IN THE DRAWINGS:

The attached sheet of drawings includes changes to FIGS. 12, 14 and 15. This sheet, which includes FIGS. 12-15, replaces the original sheet including FIGS. 12-15.

FIG. 12

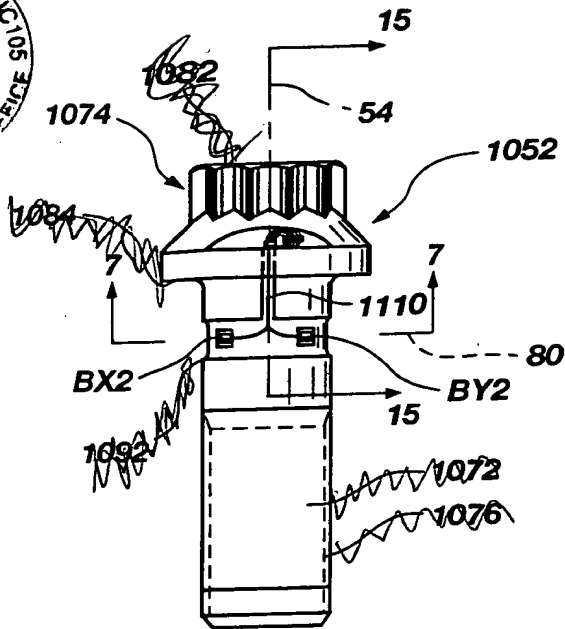
Specifically, FIG. 12 has been revised to delete the reference numerals 1072, 1076, 1082, 1084 and 1092 with appropriate lead lines (not referenced in specification); FIG. 14 has been revised to delete the reference numerals 1072, 1082, 1084 and 1092 with appropriate lead lines (not referenced in specification); and FIG. 15 has been revised to delete the reference numerals 1072, 1082, and 1092 with appropriate lead lines (not referenced in specification). No new matter has been added.
